# AXC F 2152 – CHANGE NOTES

## Change notes for the AXC F 2152 controller

Application note  
108427\_en\_23

Current firmware version: 2021.0.3 LTS

#### Left-alignable INTERBUS master

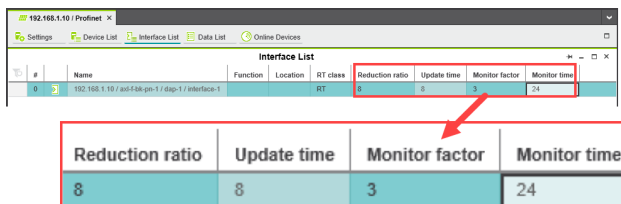
The controller now supports left-alignment of the INTERBUS AXC F XT IB master (Order No. 2403018).
